ADDENDUM NO. 1

LOGANPORT FAIRVIEW ELEMENTARY SCHOOL RENOVATIONS **Logansport, IN 46947**

ADDENDUM ONE

Addendum One (AD.01) to the drawings and specifications prepared by Gibraltar Design and The Skillman Corporation for **Fairview Elementary School Renovations** for **Logansport Community School Corporation**, Logansport, Indiana.

© GIBRALTAR DESIGN
SHEET
S-104

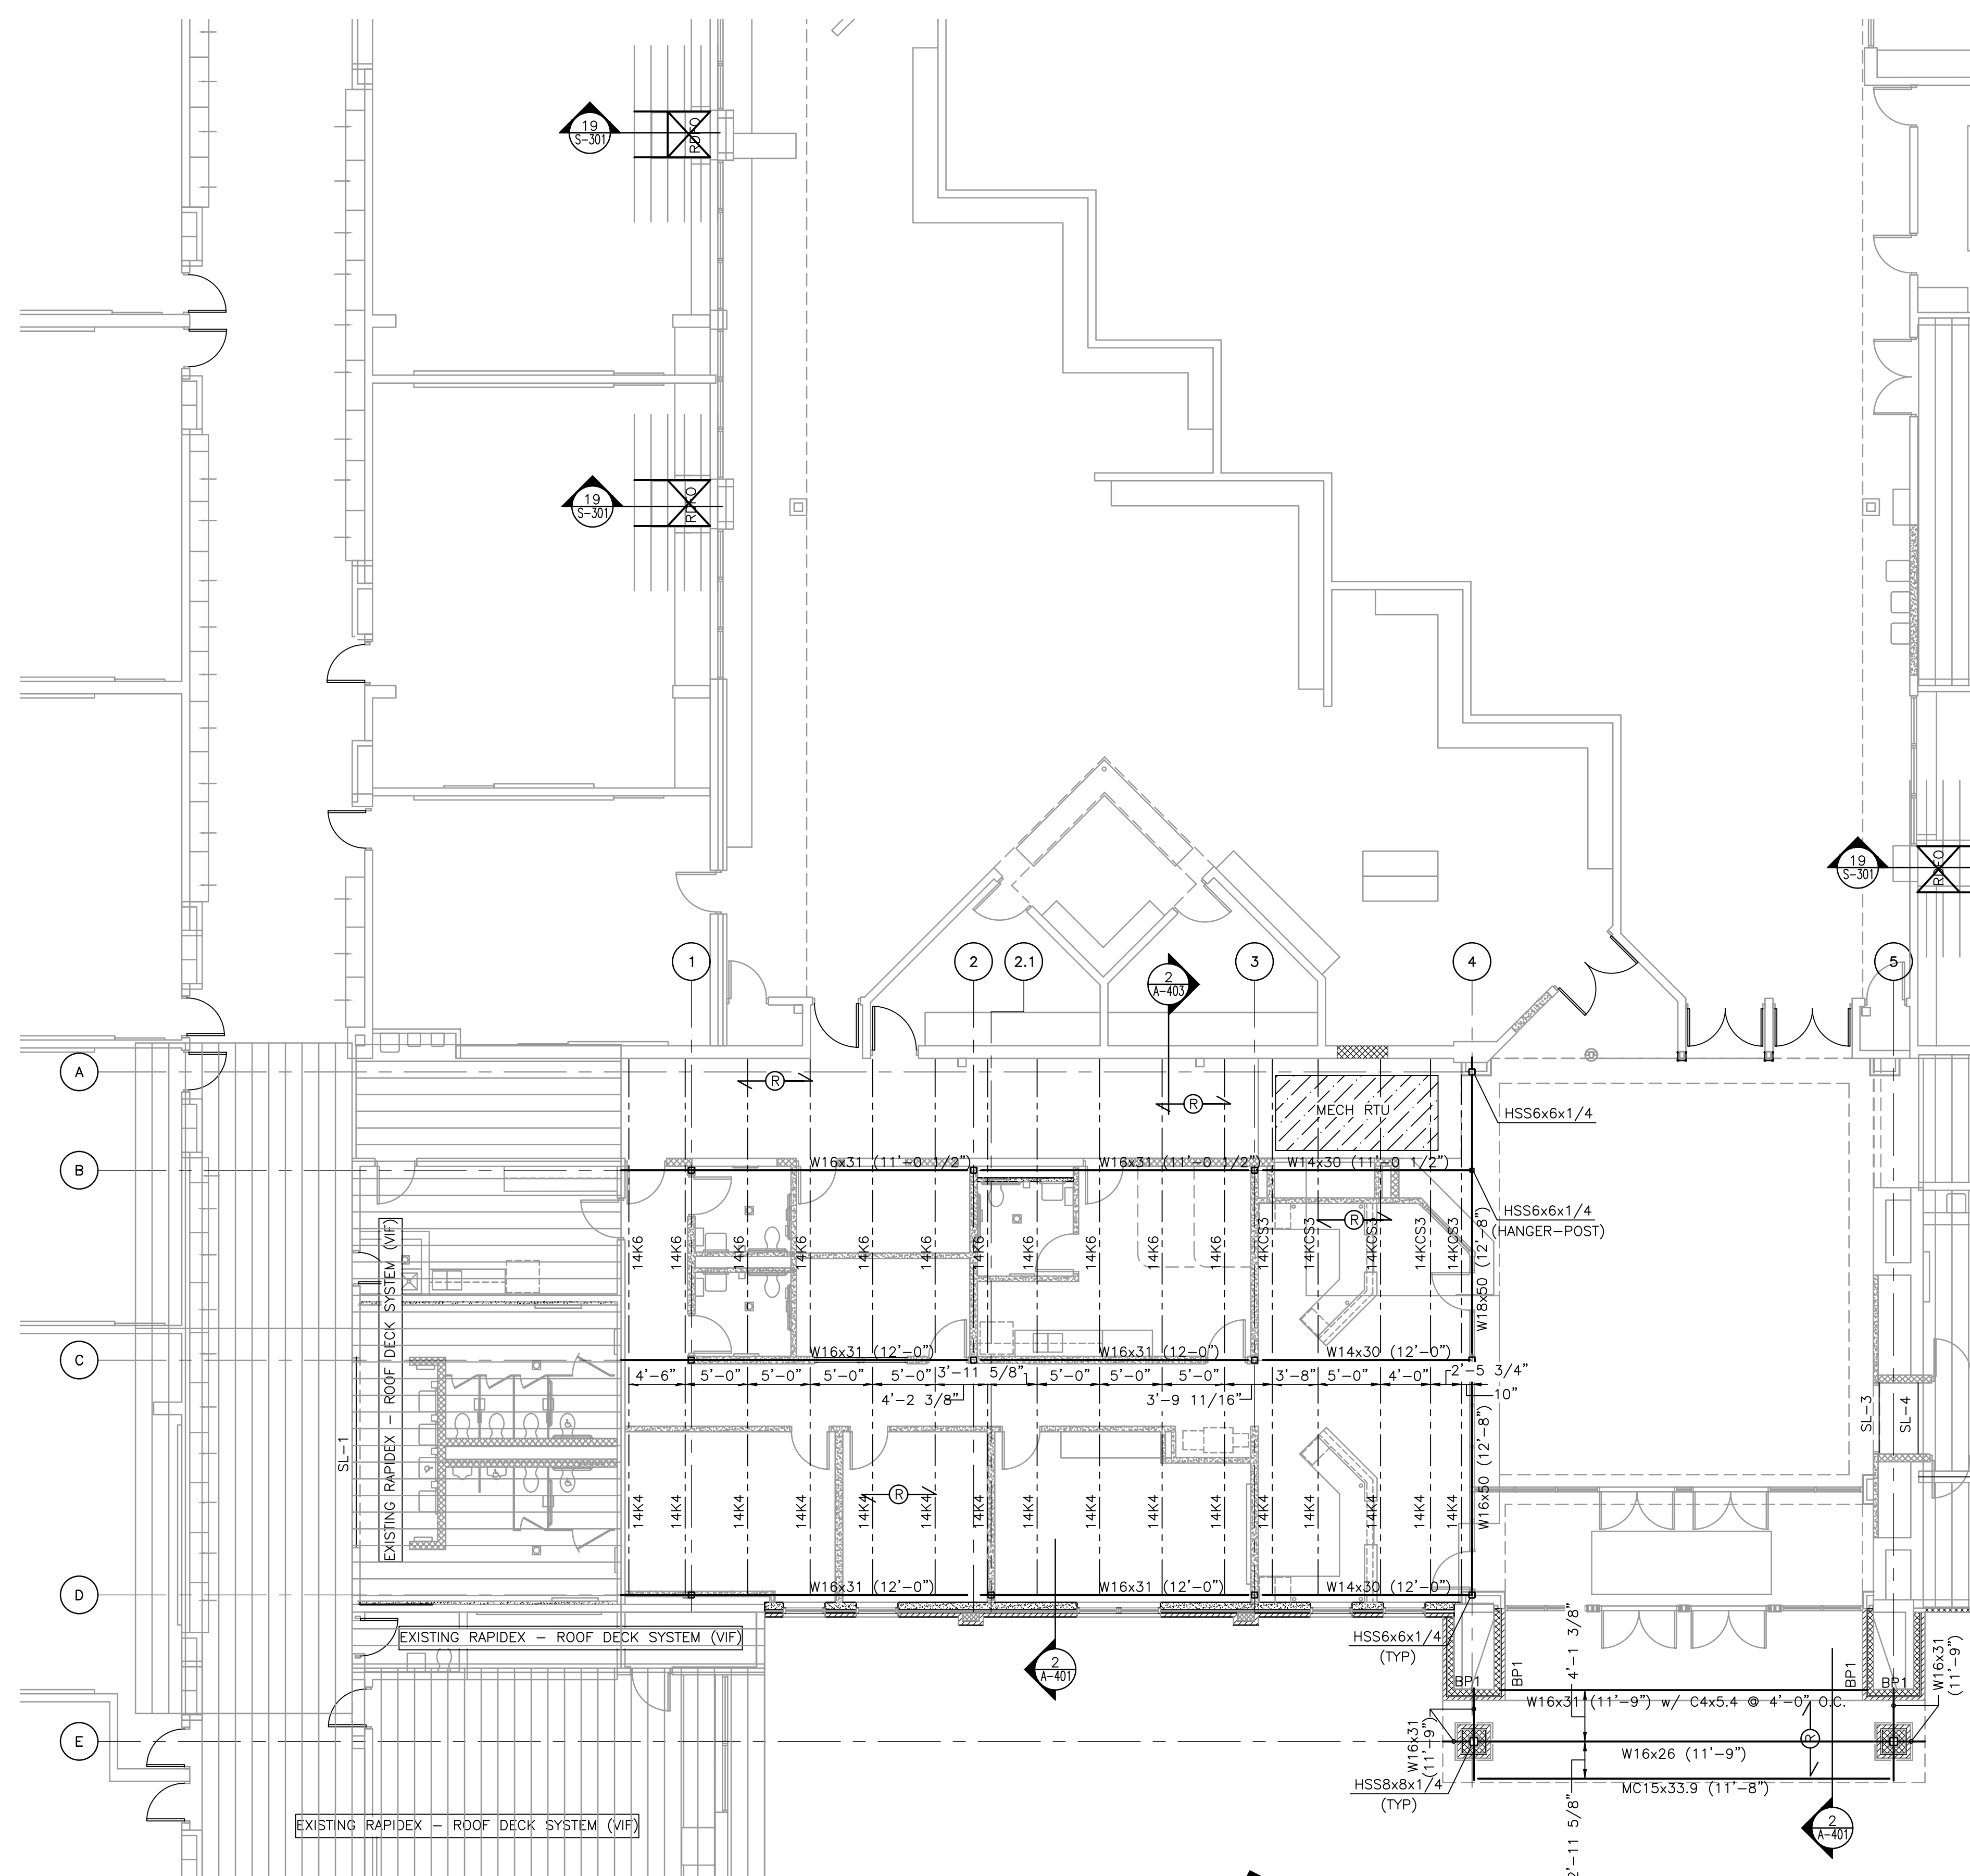
4. Sheet S-104

- A. Refer to revised full size drawing sheet, included in this addendum, for the following revisions:
 - 1. New exterior wall pilaster foundation and footing layout in Unit "A".

NEW OPENING IN EXISTING RAPIDEX ROOF SYSTEM
SCALE: 1" = 1'-0"

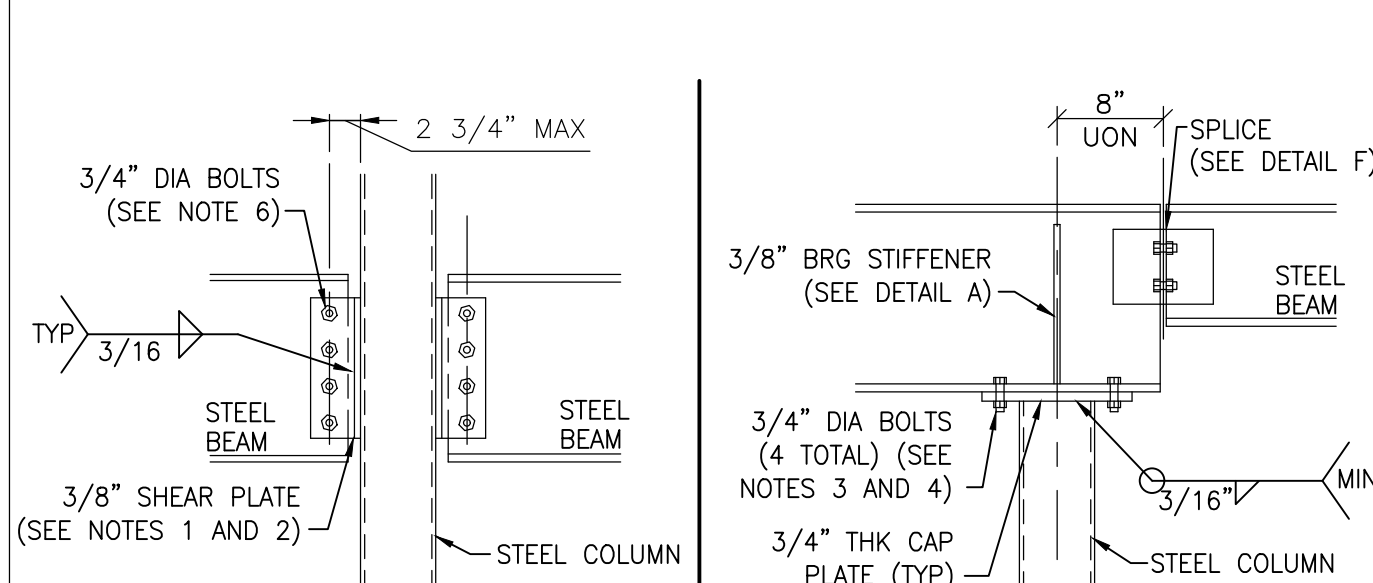
5. Sheet S-301

1. Add Detail 19/S-301 for the new opening in existing Rapidex roof System.

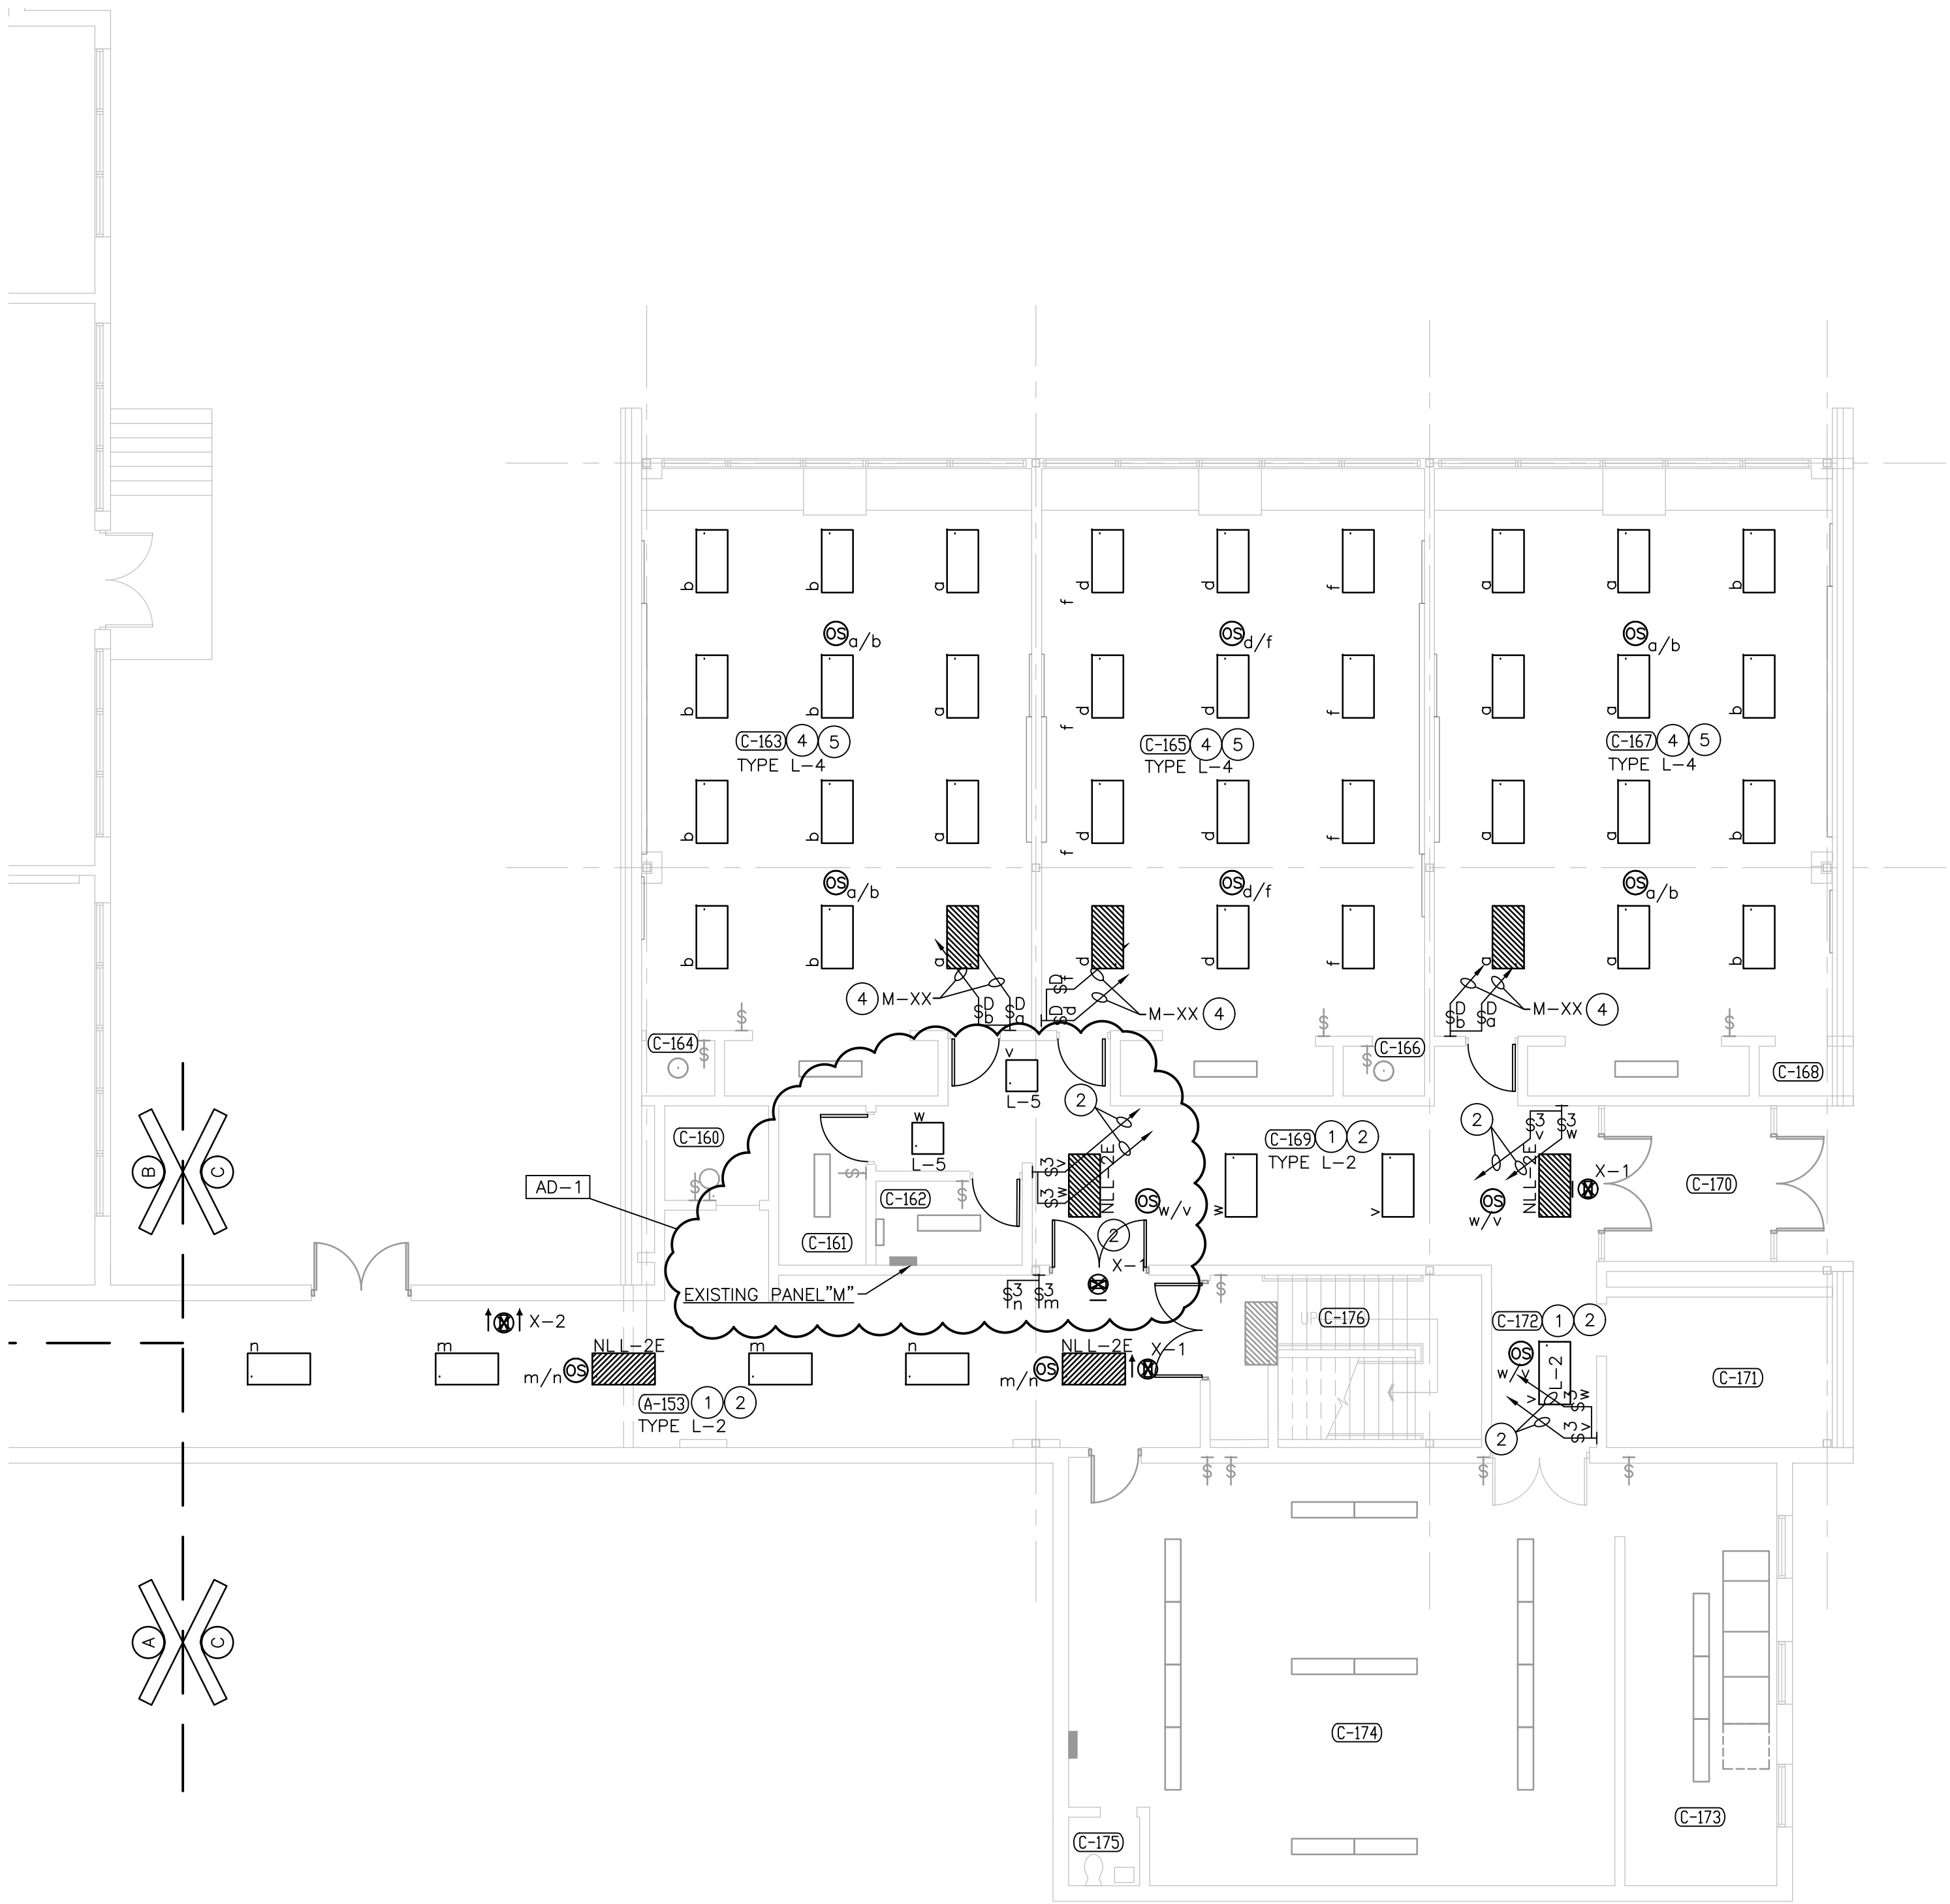
21. Sheet E-103

- A. Refer to revised full size drawing sheet, included in this addendum, for the following revisions.
 - 1. Corridor C-169. Adding lighting fixtures.
 - 2. On Plan Notes 4, 5 and 6, deleting the words "Under Alternate Bid". This work is to be under base bid.
